REPORT OF INVESTIGATING COMMITTEE  
FOR  
WILLIAMS - CHANDLER WATERSHED  
RWCD FLOODWAY, REACH I  
PINAL COUNTY, ARIZONA

Subject: ENG - Engineering Report, RWCD Floodway,  
Reach I, Williams-Chandler WPP, Arizona

Subject: ENG: Engineering Report Review  
RWCD Floodway Reach 1

ENGINEERING REPORT

LOW WATER ROAD CROSSING  
AT STA. 1315 + 00

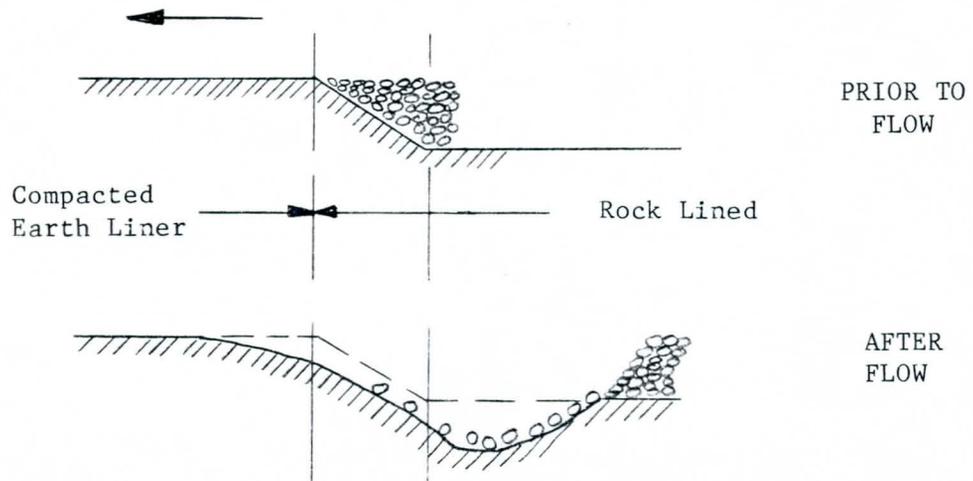
2. Bank toe erosion - Long stretches of the bank toe exhibited bank failure by erosion. In uniform reaches of the earth channel, the general bed erosion appears to have caused the toe erosion, and, with but one observed exception, bank and toe erosion in Reach I occurred on one bank or the other but never on both banks at the same section. The exception was immediately downstream of the road crossing at Station 1315 + 00, where other factors may have contributed to the most severe toe erosion in the channel (a vertical cut of 4 to 4.5 feet). As shown in the sketch above, the crossing appears to have caused a contraction of the flow. General bed scour occurred in the central portion of the channel as if it were subjected to a concentrated jet of water, with sediment disposition in the zones of stagnation on either side of the jet, and subsequent bank erosion further downstream as the jet fanned out.

# FIGURE 3

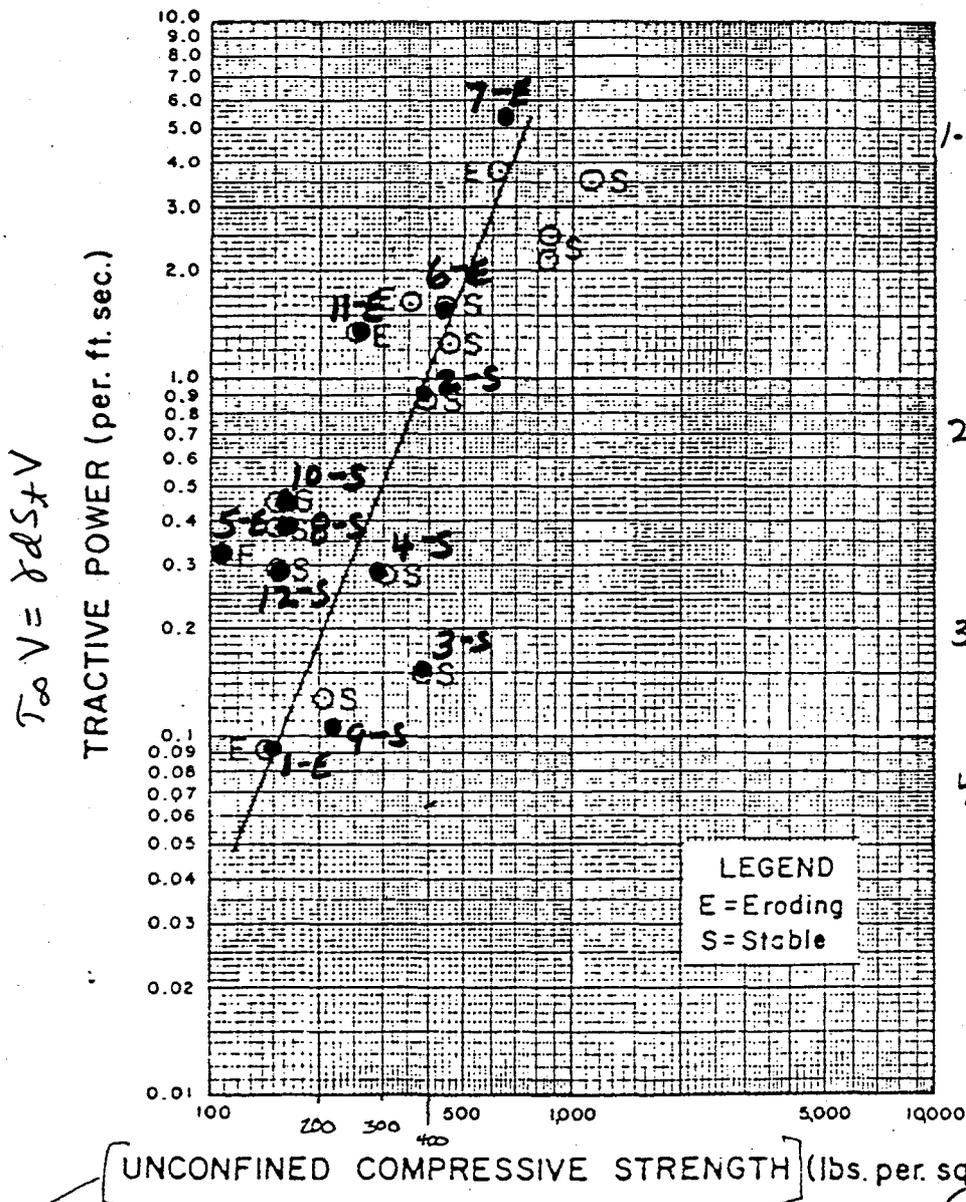
The recomputed  $\tau_{\infty} V$  values are shown in Table 2 and plotted graphically in Figure 3, the latter graph reproduced from an earlier edition of TR-25.

It would appear that the original Flaxman data was the basis for the demarcation S-line of Figure 3. Note that five additional points are shown in this earlier TR-25 edition. While the origin of these added points is unknown to the writer, they may be from channels also studied by Flaxman<sup>4</sup>. Reference 4 lists other tested channels but the data is not in a form which permits computing  $\tau_{\infty} V$ . How many of these extra plotted points were ephemeral and how many perennial could not be ascertained.

Figure 6-15

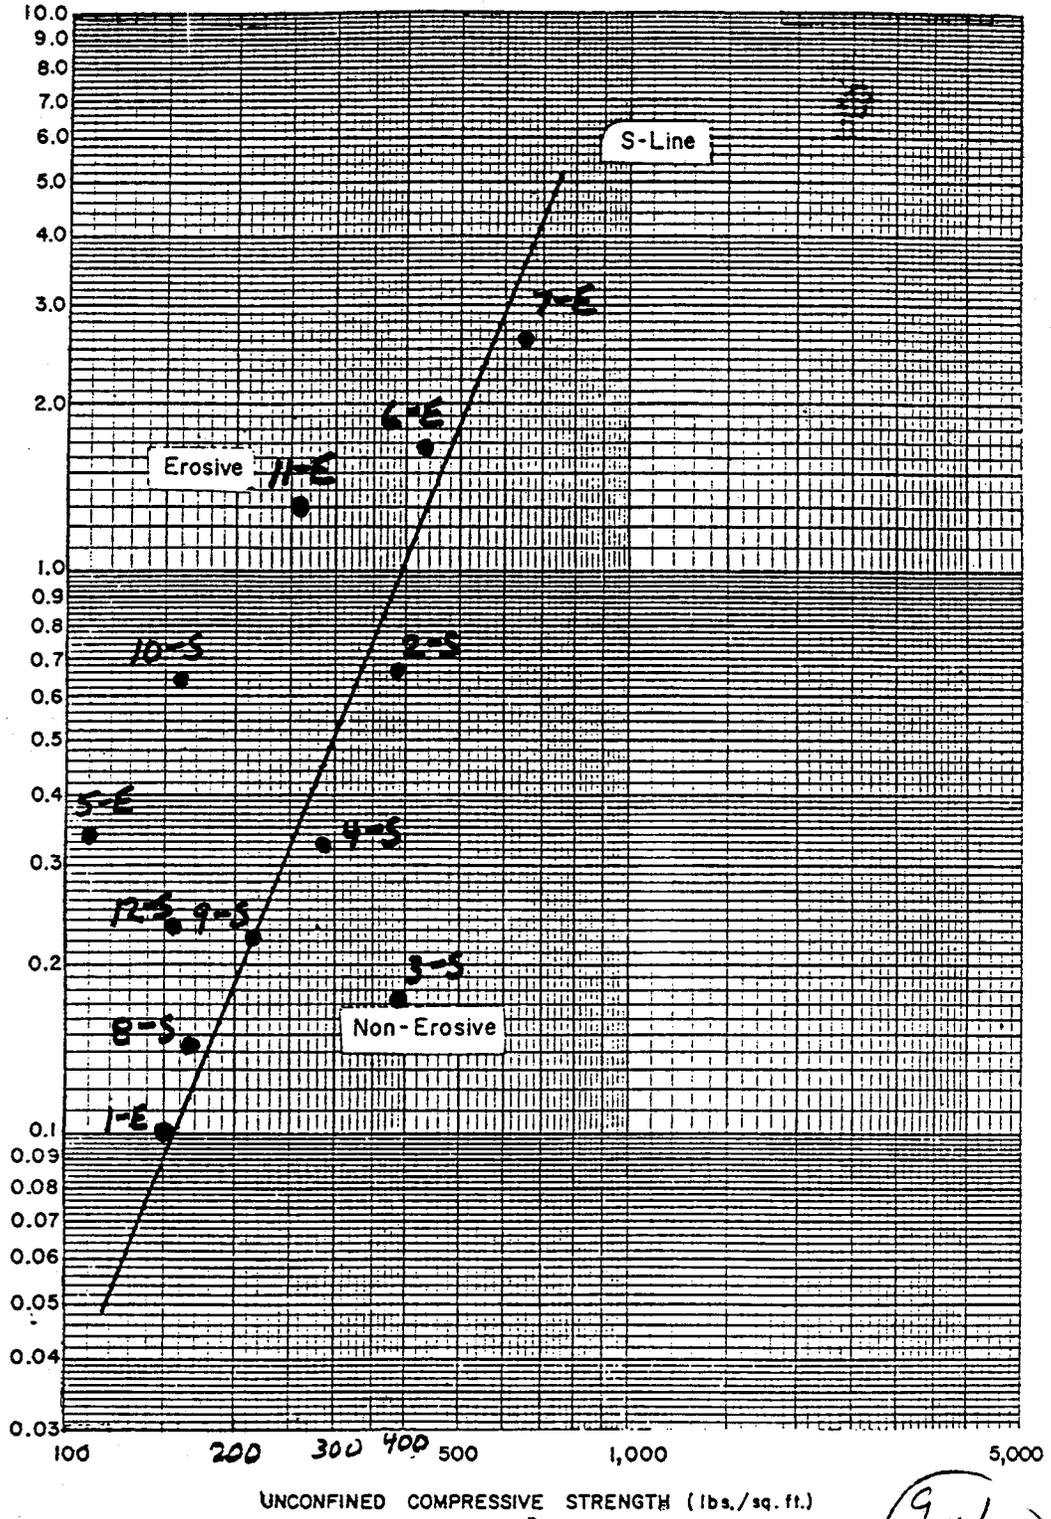
2. Figure 6-15 of TR-25 should be modified by replacing the "S-Line" with a band which would result in more conservative designs. The band would graphically signify the uncertainty of the procedure.

The 12 recomputed  $\tau_{R_t} V$  values plotted in Figure 4, Figure 6-15 of TR-25, show that point 7, marked erosive, sticks out like a sore thumb. Possibly the data for points 7 through 10 have been massaged. Were any of the five additional data points mentioned in Figure 3 designated E and did any of these plot in the stable zone? SCS does not reference much of the literature it uses.

Photo #10 - Shows local scour of soil liner immediately downstream of riprap road crossing - Sta 1317 + 00

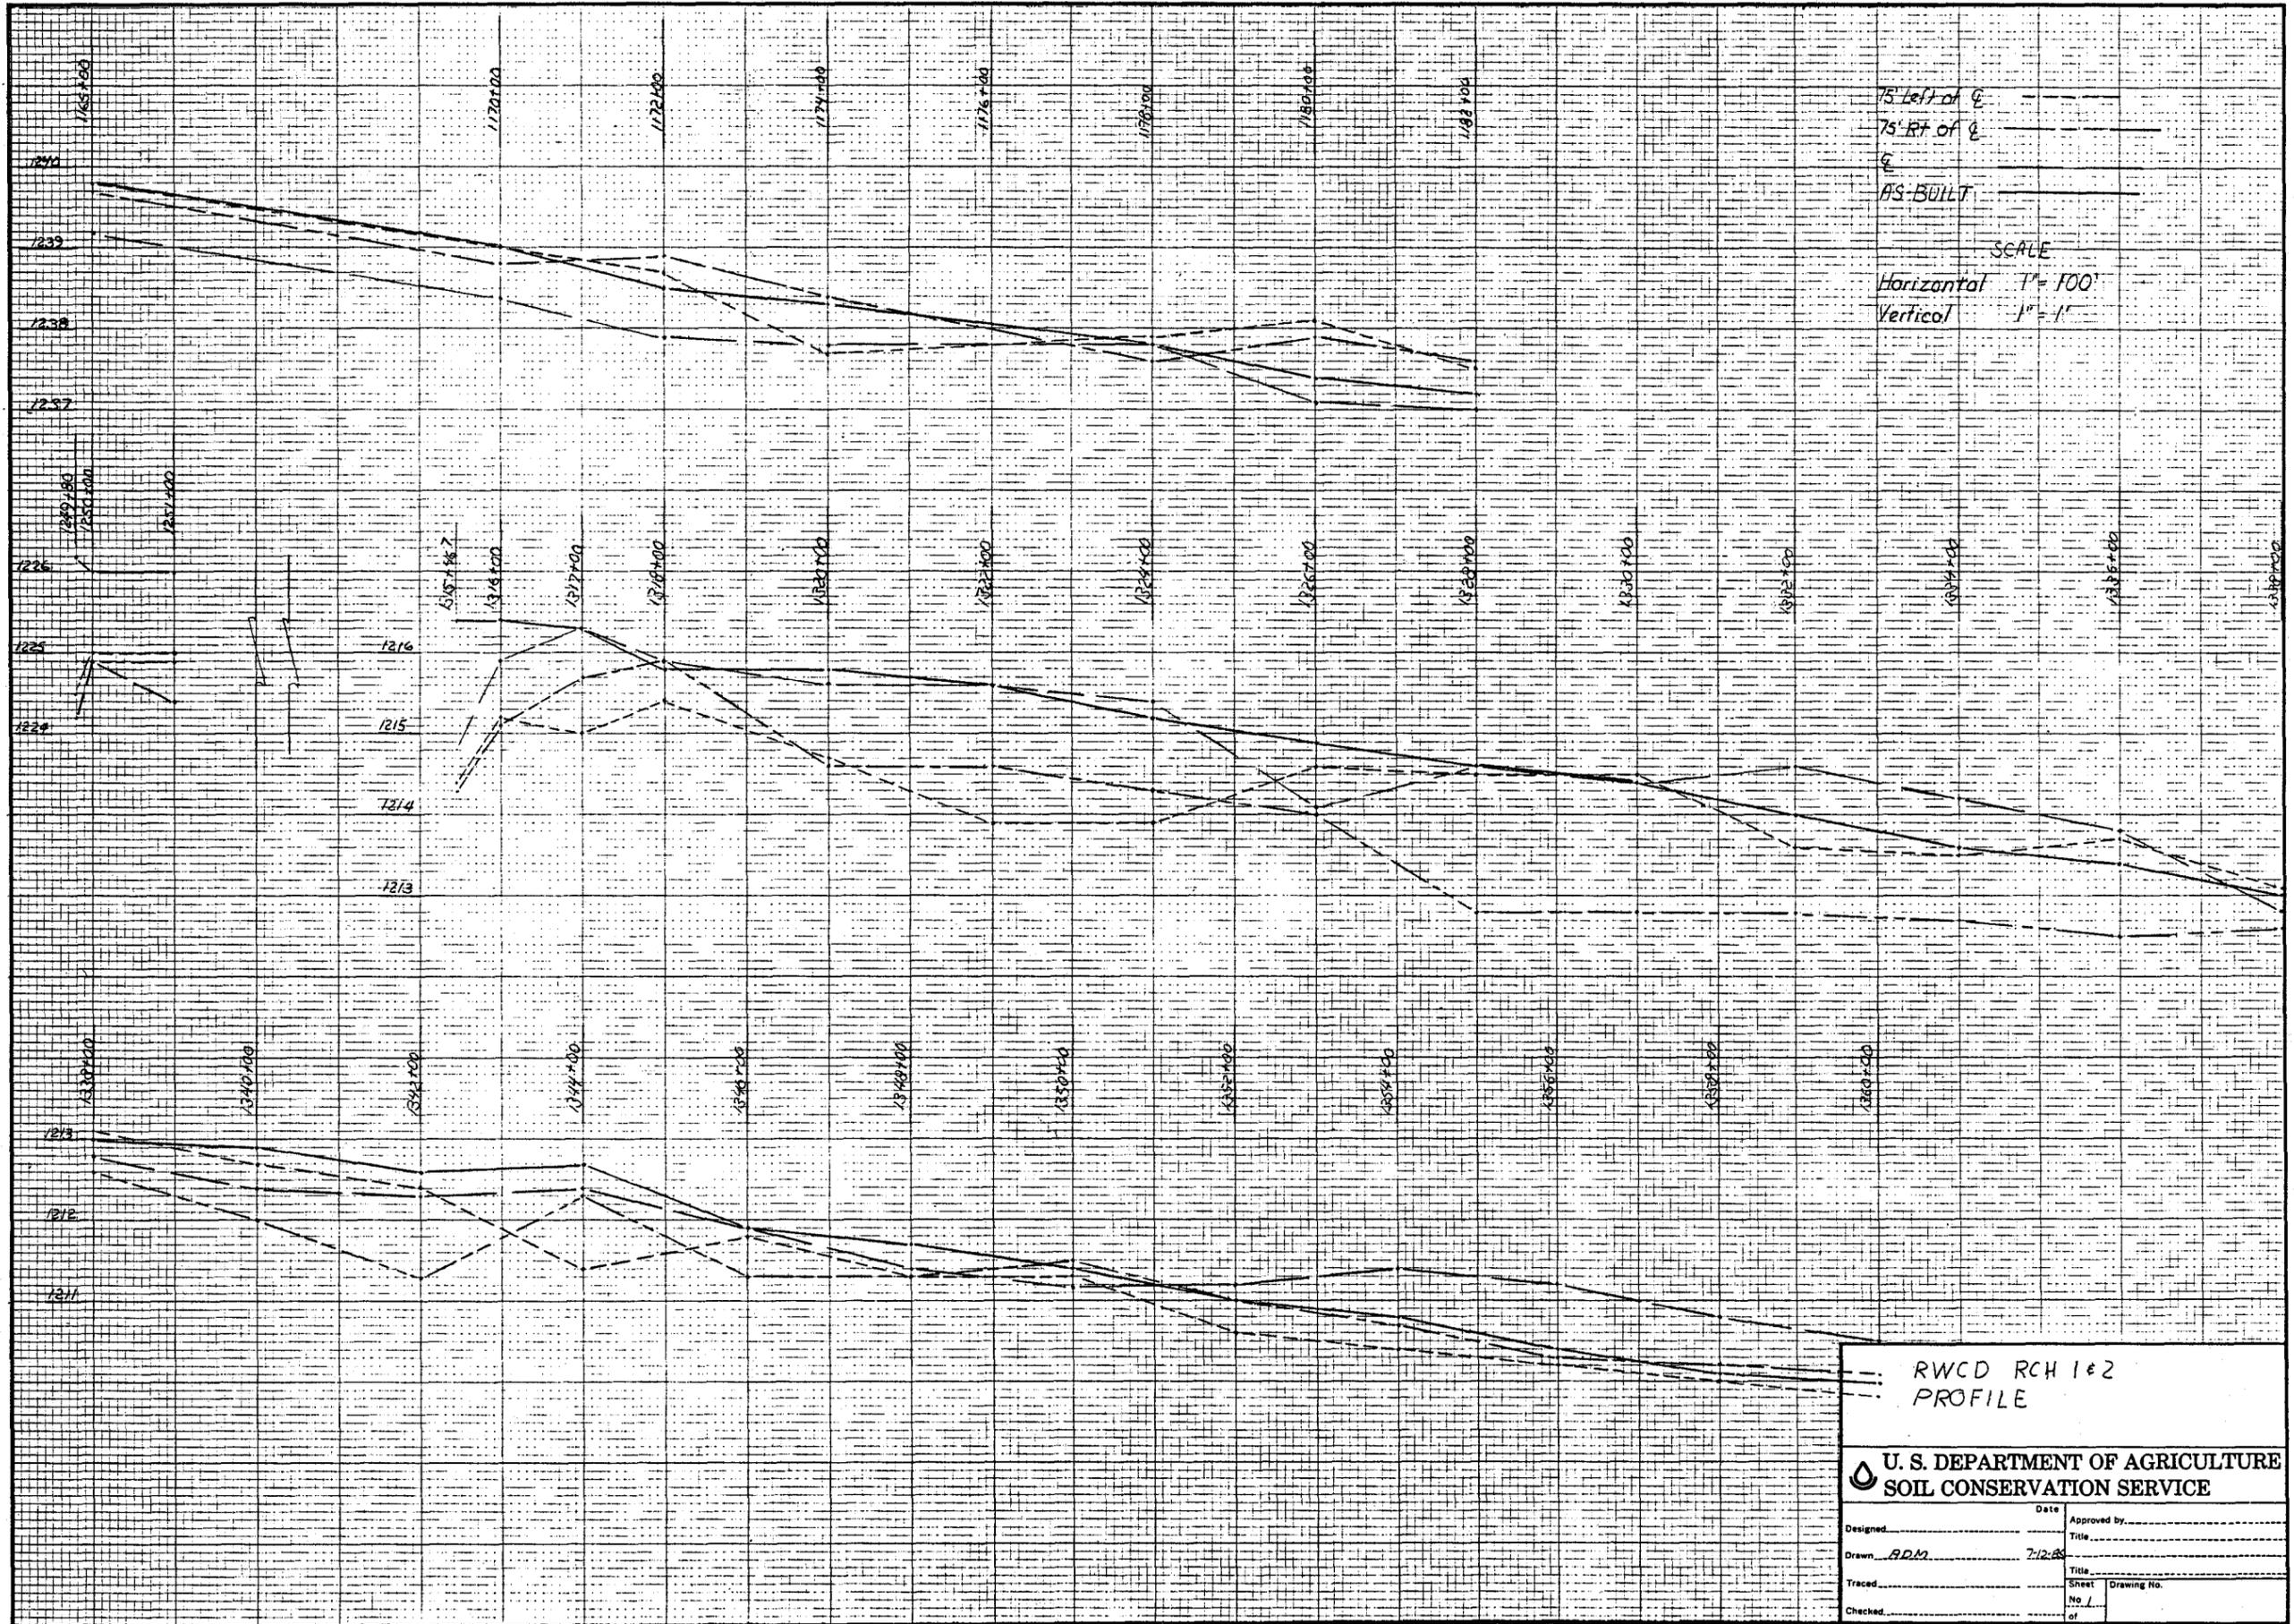
3. Localized bed erosion - Bed erosion occurs immediately downstream of most of the riprap reaches; however, the erosion is much greater below some riprap reaches than others. At the downstream end of the riprap reaches where soil erosion does occur, the erosion is not uniform across the channel section. In fact, it is "saw tooth" in that there are areas of deep erosion next to areas of basically no erosion. At some of these locations, the scoured soil surface is well below the riprap surface.
